ADMINISTRATIVE AMENDMENT

FILE # ^{SI-2020} -00073 **PROJECT #** ^{PR-2020} -003539

Alternative signage to replace green-faced signs with white-faced signs.

NORTH ELEVATION

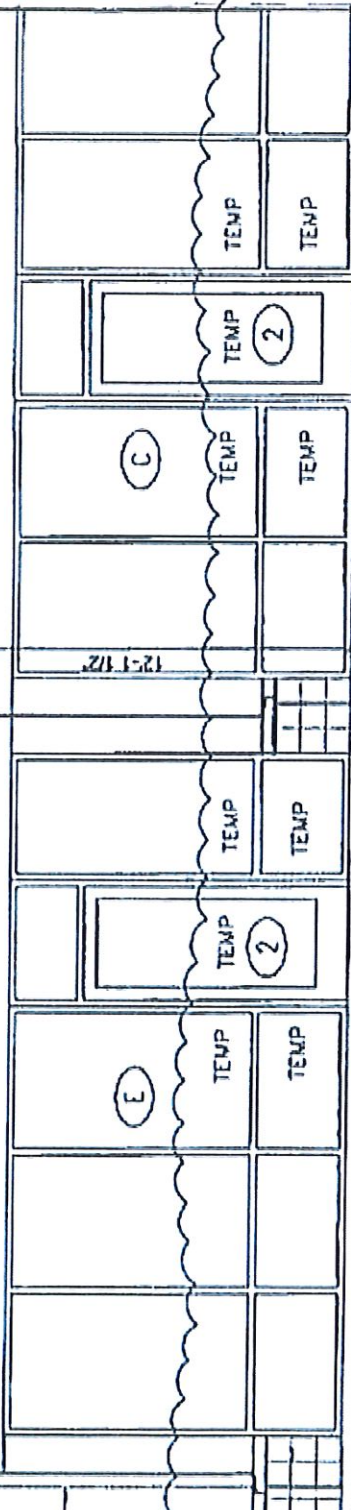
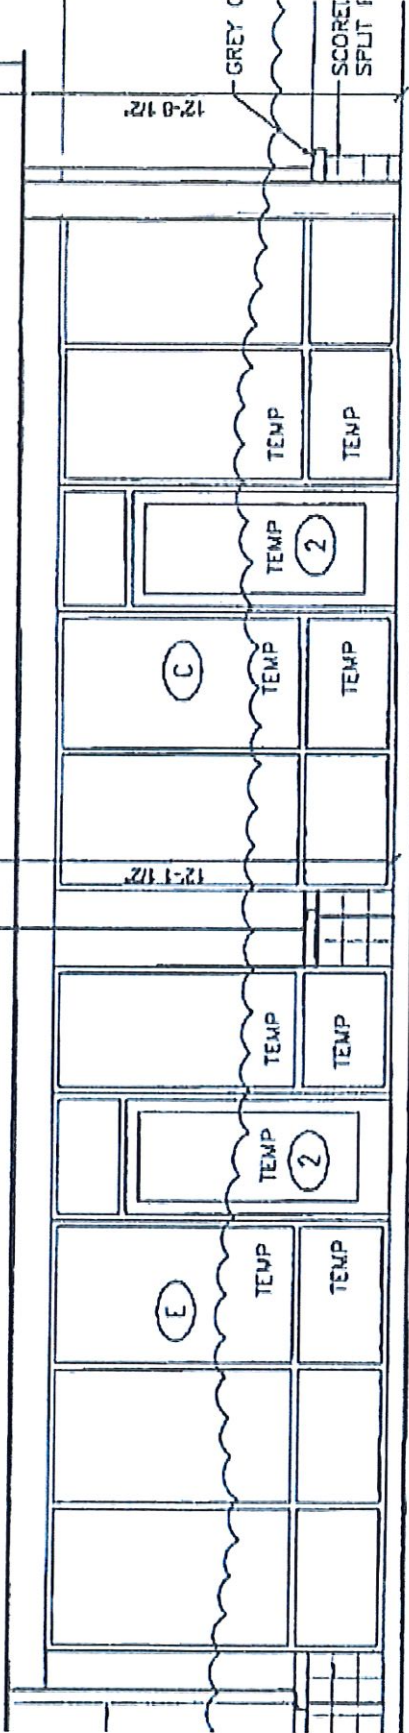
INTERNALLY LIT
INDIVIDUAL CHANNEL
LETTERS (GREEN) WHITE
& 'DRIVE-THRU' OVAL
48 SQ. FT. MAX.

NORTH ELEVATION | PROPOSED REPLACEMENT DISPLAY Scale: 1/4" = 1'- 0"

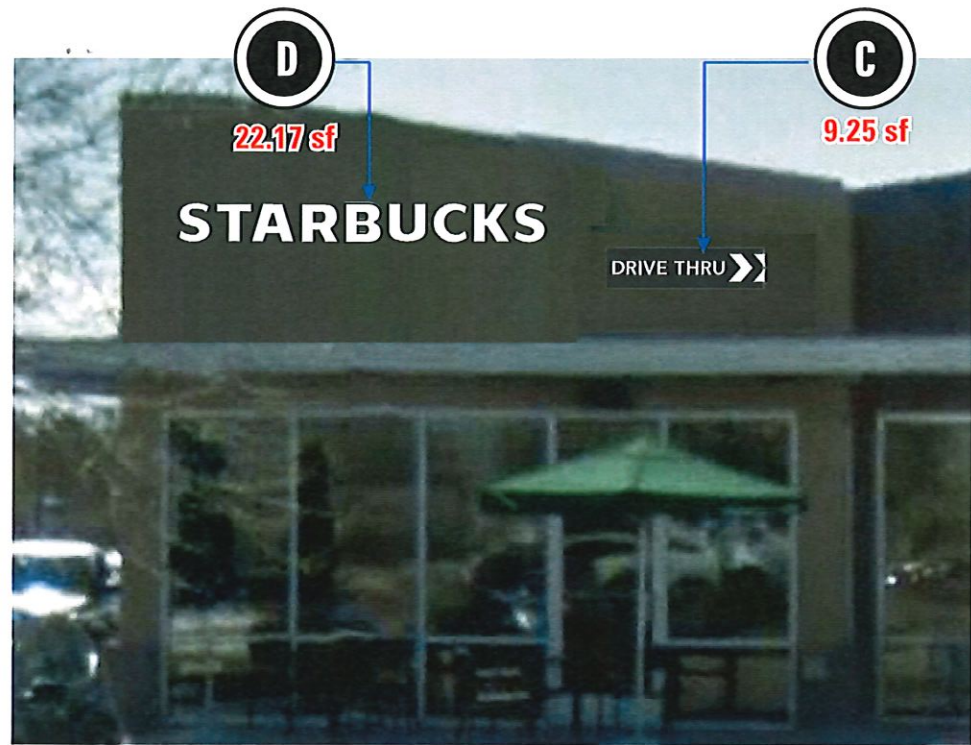
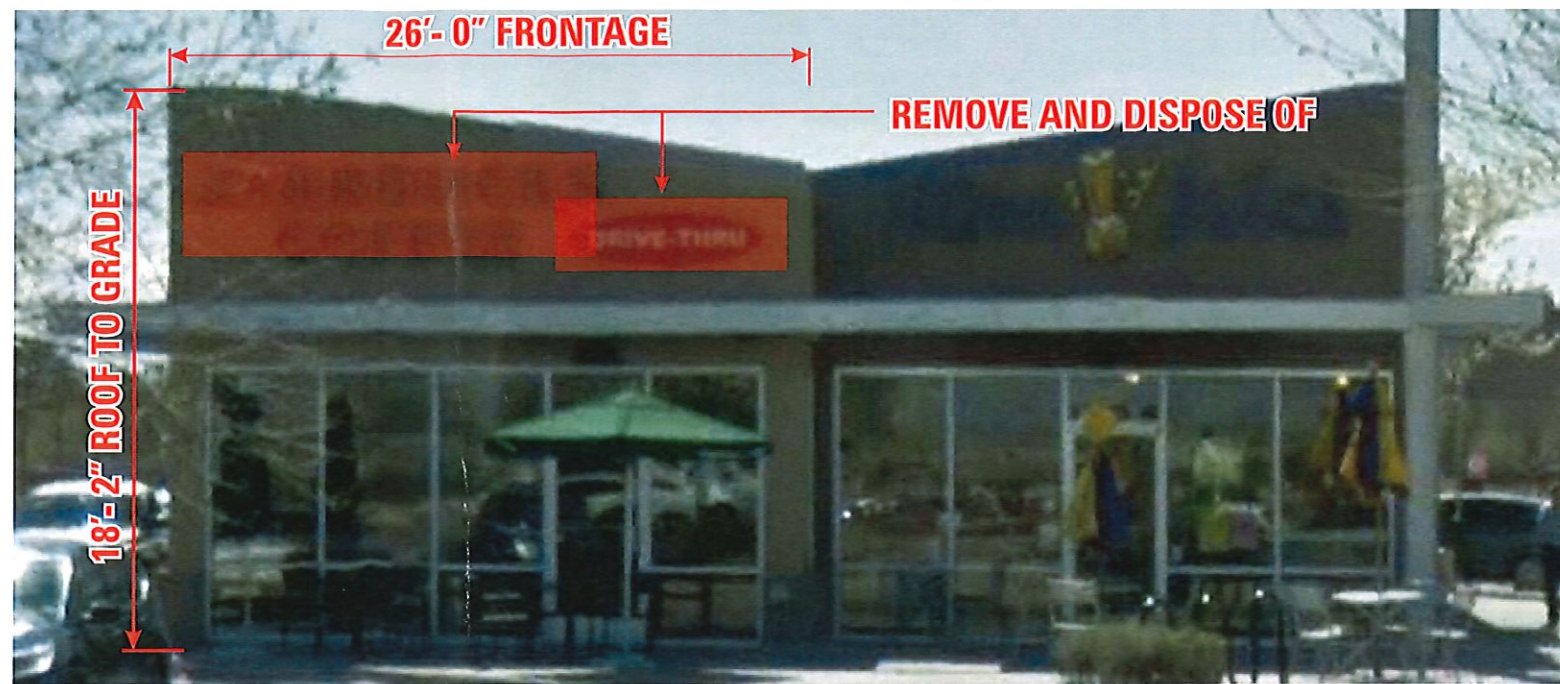
PERMITTING	
A	36" "Siren" LOGO DISC _____ 9.00 sf
B	18" "STARBUCKS" PCL _____ 22.17 sf
C	DRIVE THRU CABINET _____ 9.25 sf
D	18" "STARBUCKS" PCL _____ 22.17 sf

EXISTING DISPLAYS TO STAY UNTOUCHED

EAST ELEVATION | PROPOSED REPLACEMENT DISPLAY Scale: 3/16" = 1' - 0"

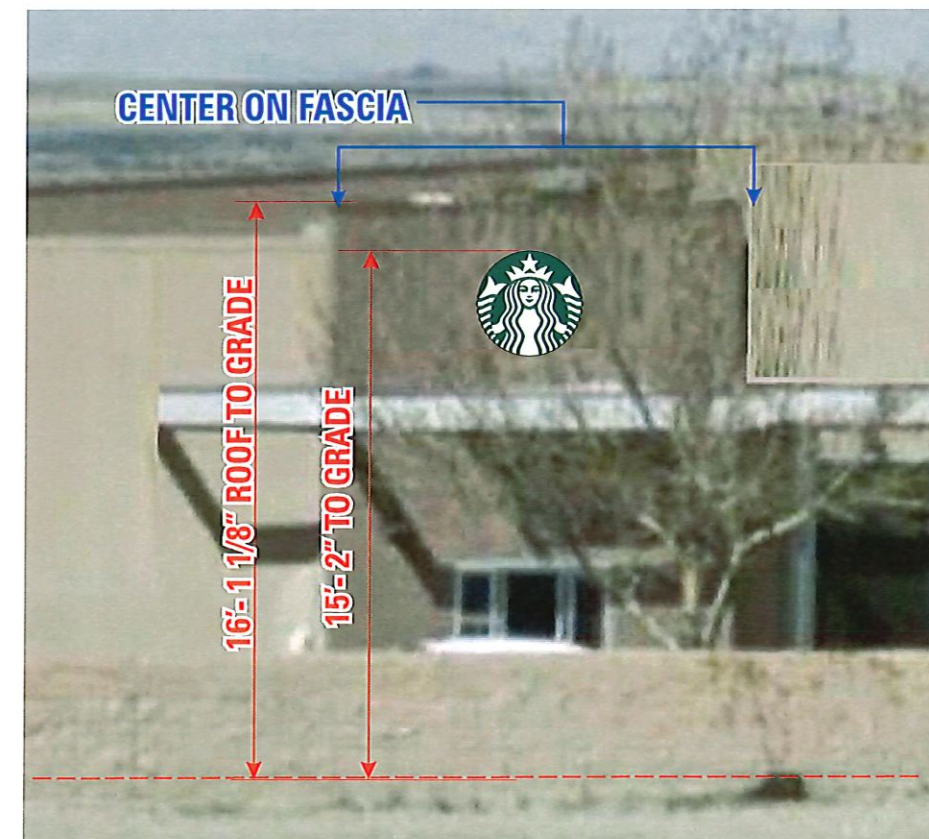
Remove and dispose of existing "Drive Thru" cabinet and discard. Weather proof holes. No painting included.

Receive, Inspect and Install one (1) new "Siren" logo cabinet. Attach flush to wall.

EAST ELEVATION | PROPOSED REPLACEMENT DISPLAY Scale: 3/32" = 1'-0"

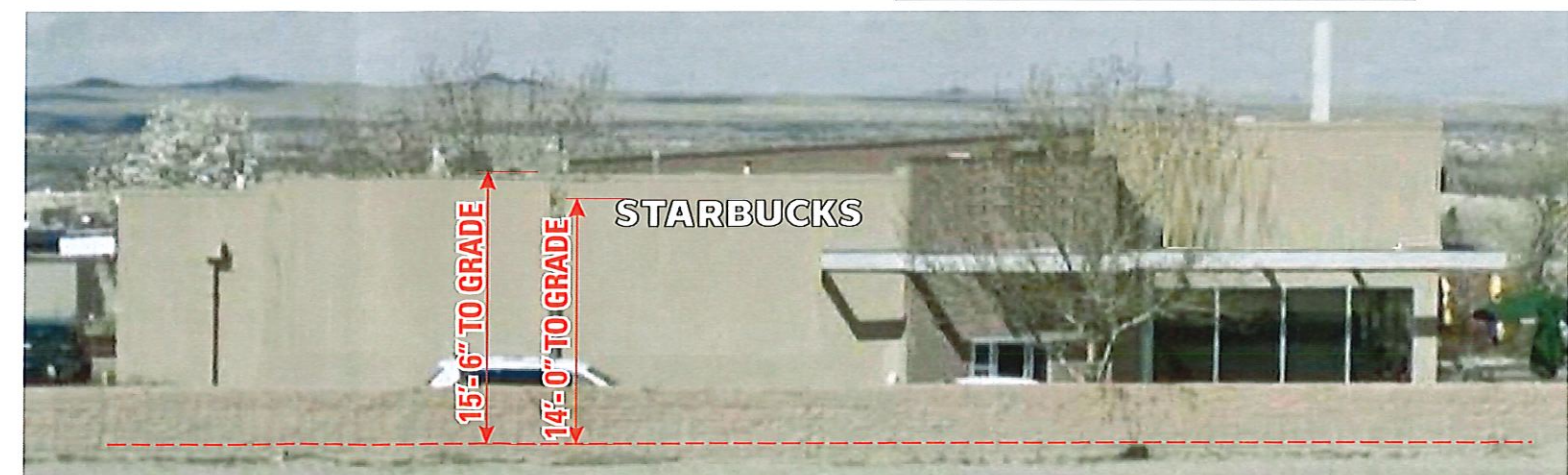
Scope of Work
 Remove and dispose of existing letter set "STARBUCKS COFFEE". Weather proof holes. No painting included.

Receive and install one (1) set of internally illuminated S/F channel letters. Faces to be 3/16" #015-2 White acrylic w/ 1" black trim cap. 5" black returns. Attach flush to fascia. Connect to existing 120v circuit

NORTH ELEVATION | PROPOSED REPLACEMENT DISPLAY

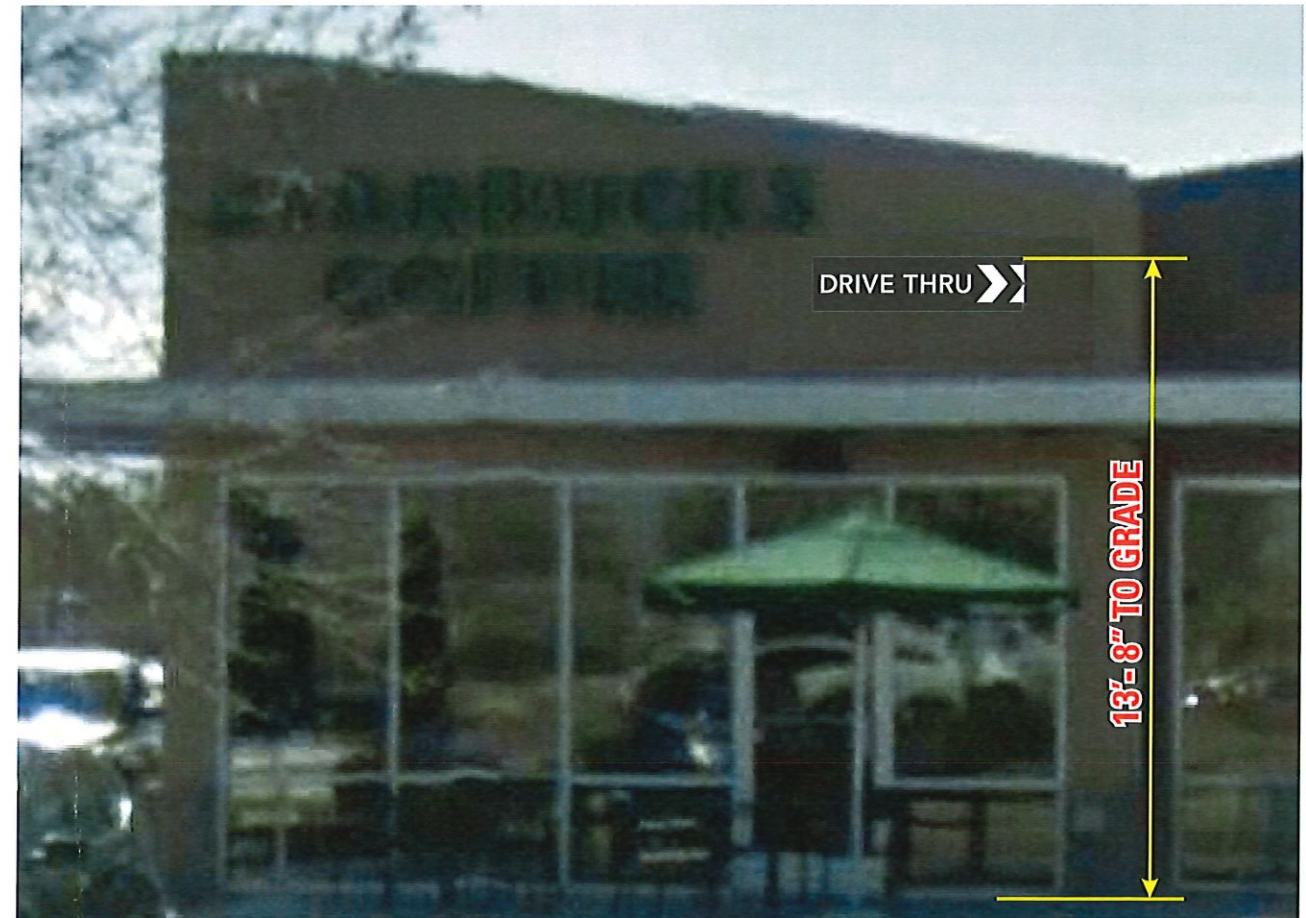
Scope of Work
Receive and install one (1) internally illuminated S/F wall cabinet.
Routed aluminum face w/ white poly carboanate back up.
Attach flush to fascia.
Connect to existing 120v circuit.

NORTH ELEVATION | PROPOSED REPLACEMENT DISPLAY

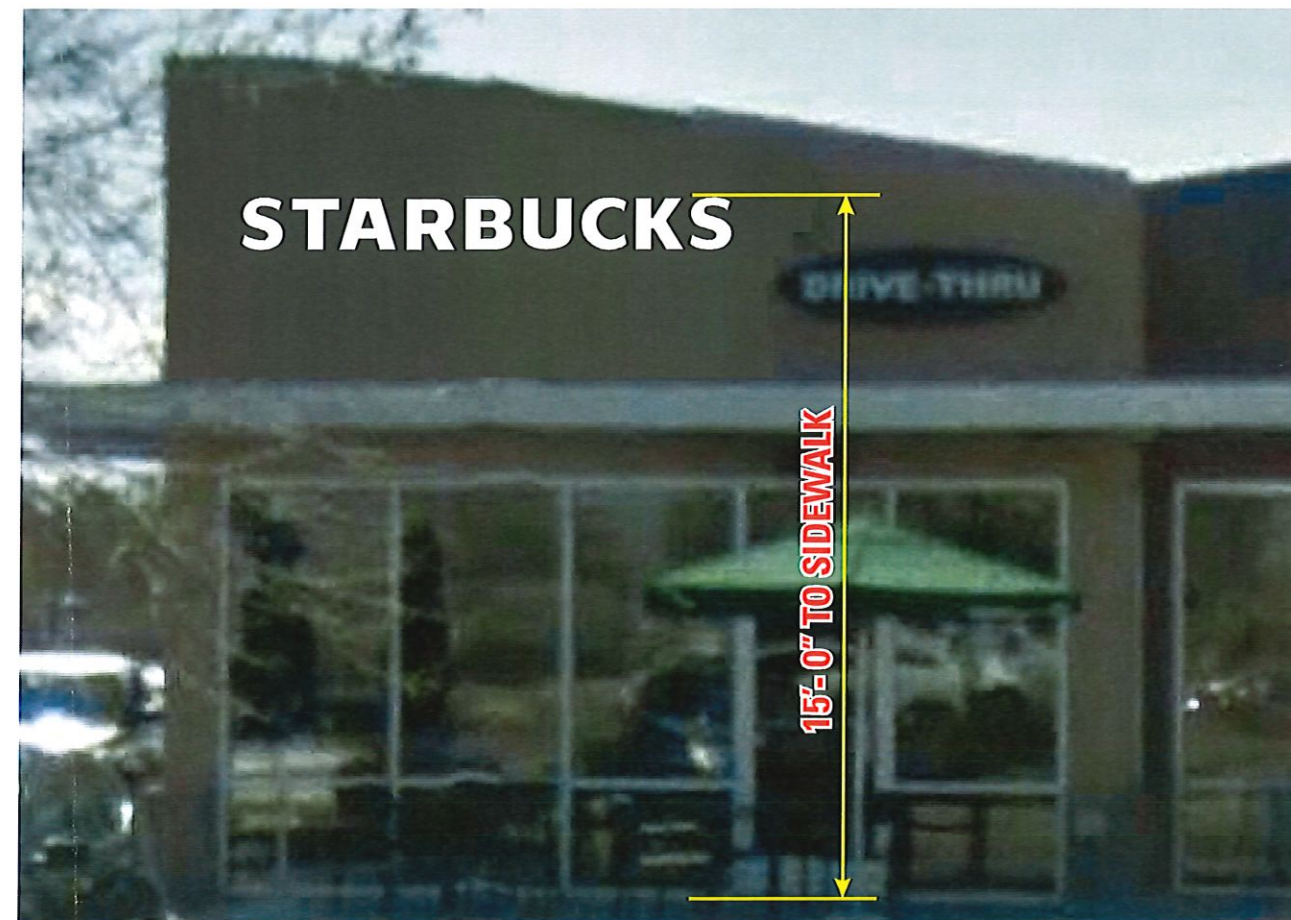
Remove and dispose of existing letter set "STARBUCKS COFFEE". Weather proof holes. No painting included.

Receive and install one (1) set of internally illuminated S/F pan channel letters. Faces to be 3/16" #015-2 White acrylic w/ 1" black trim cap. 5" black aluminum returns. Attach flush to fascia. Connect to existing 120v circuit.
